Access Compliance Report Public Rights-of-Way (Curb Ramps)

Main Street: CRAWFORD_CANYON_RD Cross Street: STOLLER_LN Location: SW

ADA ID: RPRK211007172919 Ramp Type: Type 1 - Perpendicular Diagonal Initial Pass/Fail: Fail Overall Compliance: No Severity Score: 30

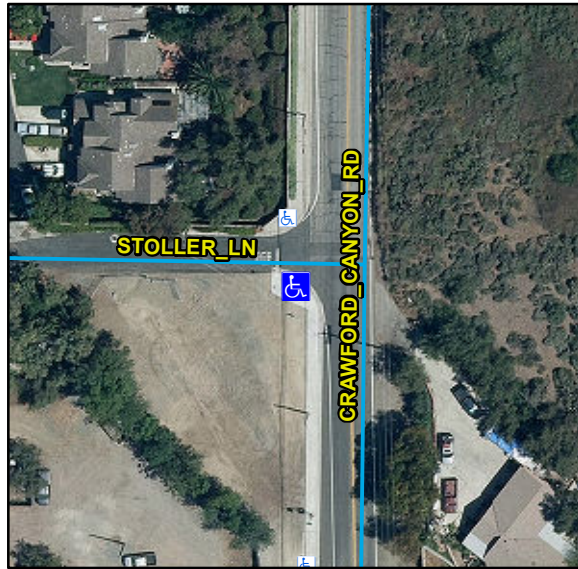
Compliance	Description	Data	Compliance	Description	Data
N/A	Ramp Length (in)	91	N/A	Flare Type LT	
Yes	Ramp Width (in)	48			N/A
No	Ramp Run Slope (%)	12.1	N/A	Flare Slope LT (%)	N/A
Yes	Ramp Cross Slope (%)	0.7	N/A	Flare Traversable LT	N/A
N/A	Landing Present	N/A	N/A	Flare Type RT	
N/A	Landing Length (in)	N/A			N/A
N/A	Landing Width (in)	N/A	N/A	Flare Slope RT (%)	N/A
N/A	Landing Run Slope (%)	N/A	N/A	Flare Traversable RT	N/A
N/A	Landing Cross Slope (%)	N/A	N/A	DWS Provided	N/A
N/A	Landing Movement Obstructed?	N/A	N/A	DWS Contrast	N/A
	Landing Movement Type	N/A	N/A	DWS Length (in)	N/A
N/A	Landing Shared	N/A	N/A	DWS Full Width	N/A
N/A	Clear Space	Yes	N/A	DWS Offset Left (in)	N/A
N/A	Clear Space To Crosswalk (in)	N/A	N/A	DWS Offset Right (in)	N/A
N/A	Marked Crosswalk 1	No	N/A	Marked Crosswalk 2	No
	Crossing 1 Direction	E		Crossing 2 Direction	N
	Marked Crosswalk 1 Width (in)	N/A		Marked Crosswalk 2 Width (in)	N/A

N/A	Ramp Inside Crosswalk 1	N/A	Yes	Ramp Inside Crosswalk 2	N/A
	Crossing 1 Slope (%)	11.2		Crossing 2 Slope (%)	5.5
	Crossing 1 Cross Slope (%)	5.9		Crossing 2 Cross Slope (%)	5.6
N/A	Gutter Ponding	N/A	N/A	Curb Slope	4.2
Yes	Gutter Lip Height (in)	0		Road Run Slope (%)	4.5
N/A	Gutter Run Slope (%)	N/A		Road Cross Slope (%)	2.9
N/A	Gutter Cross Slope (%)	N/A			
Yes	Overall Surface Condition: Acceptable		No	Perp Joint Present	No
	Cross Gutter Present?	No		Spandrel Present?	No
	Replace Cross Gutter?	N/A		Replace Spandrel?	N/A

Remove & Replace Curb Ramp With Two New Directional Ramps or Equivalent.

R204.3, R304.2.2, STD 1115
